Notice of Allowability	Application No.	Applicant(s)	
	10/710,383	YAMADA, TAKASHI	
	Examiner Nguyen N. Hanh	Art Unit 2834

EXAMINER'S AMENDMENT

FIG. 8

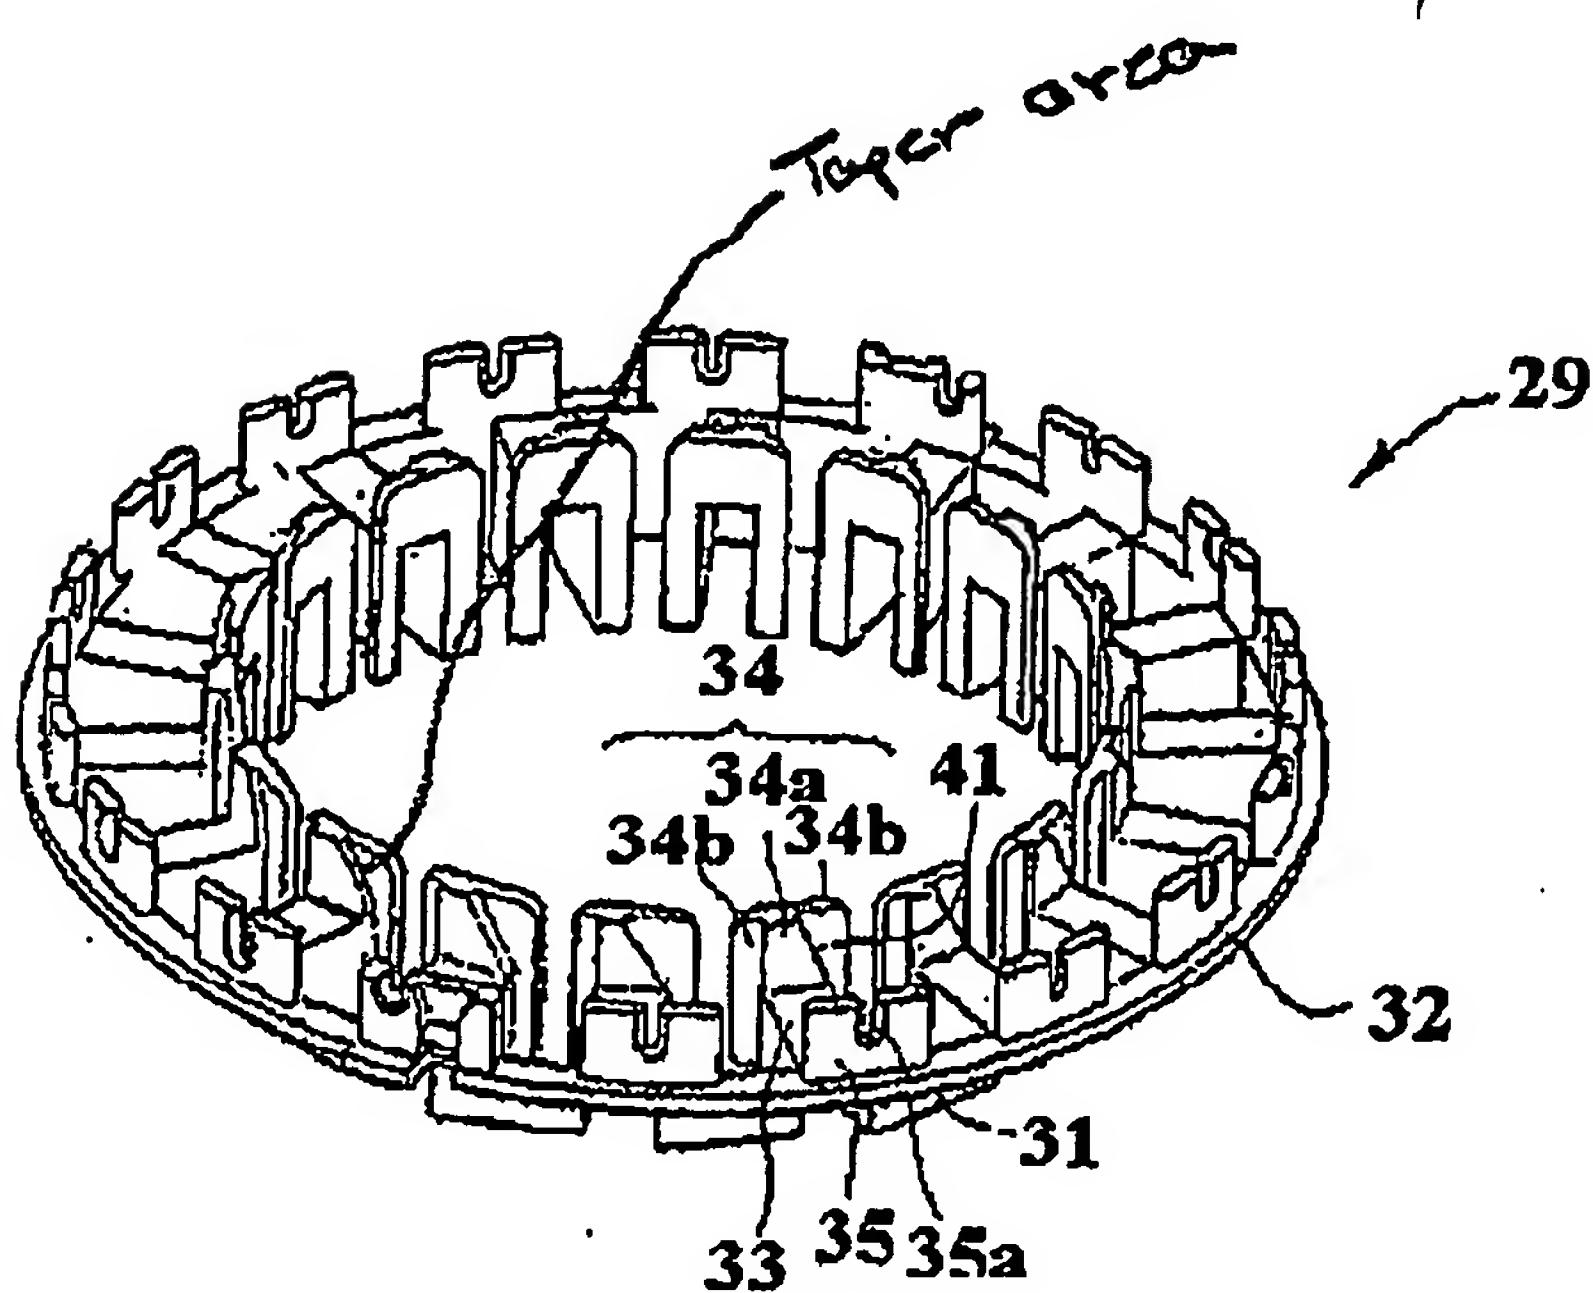
For illustration purpose
only , not an aminded
drawing:
